**AERONAUTICAL TELECOMMUNICATIONS NETWORK PANEL**

**SME V (Internet Communications Service)  
Status Report**

**Working Paper**

This paper provides a summary on the status of the PDRs which have been raised against the ATN ICS SARPs (Subvolume 5).

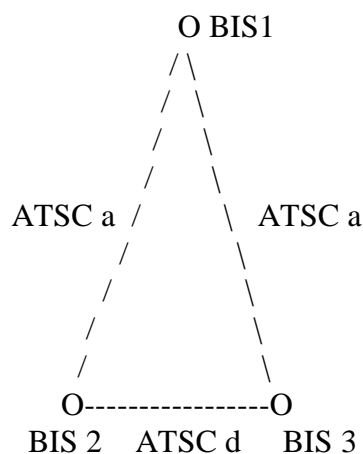
The problem is observed in an ATN network when a BIS downgrades the ATSC class of the routes as permitted by SARPs section 5.8.3.2.4.2.1.d).

Consider the following meshed topology with 3 BISs, each belonging to a different Routing Domain:

The links (BIS1-BIS2) and (BIS1-BIS3) are high speed, low transit delay links, and the routers are configured so that they will not downgrade the ATSC class of routes advertised over these links.

On the other hand, the link (BIS2-BIS3) is a high transit delay link, and routers BIS2 and BIS3 are configured to downgrade the ATSC class of routes advertised over that link (according to SARPs section 5.8.3.2.4.2.1.d)).

For instance, it is assumed that Class A routes are downgraded to Class D routes when advertised over that link.

Let's assume that BIS 1 is currently advertising an ATSC Class A route (e.g. the route to the French RD).

BIS 2 receives this class A route from BIS 1 and re-advertises this route as a class D route to BIS 3. In the same way, BIS 3 receives this class A route from BIS 1 and re-advertises this route as a class D route to BIS 2.

The problem is observed when BIS 2 has to forward a CLNP PDU with a class 'D' security tag and the destination of which is in the French RD.

According to its routing table BIS 2 forwards the CLNP PDU to BIS 3; then BIS 3 re-forward the CLNP PDU to BIS 2; and the ping-pong game continues until the lifetime of the CLNP PDU expires. The CLNP PDU never reaches its destination.
